SERVICE BULLETIN

APPLICABILITY: 2018-21MY Crosstrek
2017-23MY Impreza

SUBJECT: Cowl Panel – Design Change

NUMBER: 12-321-21R
DATE: 07/19/21
REVISED: 08/14/23

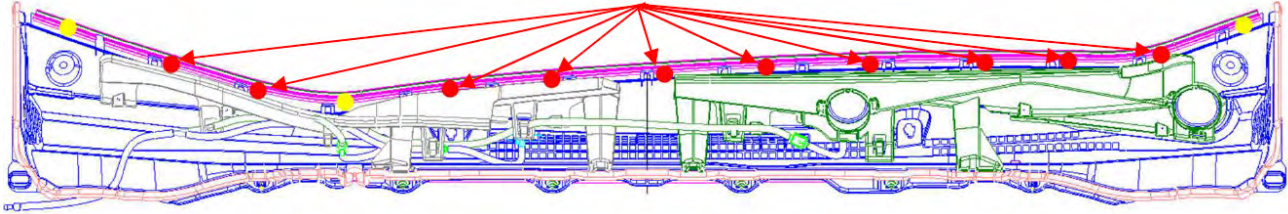
This bulletin announces a design change made to the cowl panel. These new parts utilize ten additional fixing points between the cowl panel and its rubber protector. This change was made to address a small number of cases where the rubber sealing portion had become separated as shown below. If this issue is confirmed, the cowl panel must be replaced.

10 additional fixing points have been incorporated into the new cowl panel.
